88 88 6 111 630	MAIN GROUP 11 ENGINE	Special tools Motorcycle
Drift		On Tool Board 000 530

Output shaft seal installing tool

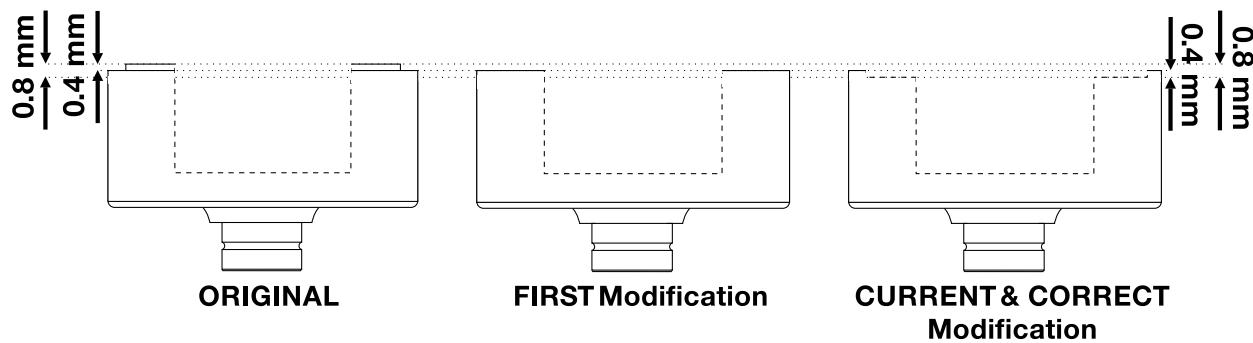
The original arbor 111 630 was first modified by lowering the seal contact area 0.4mm to create a flush frontal area. 111 630 was again modified by undercutting the seal contact area by 0.4 mm.
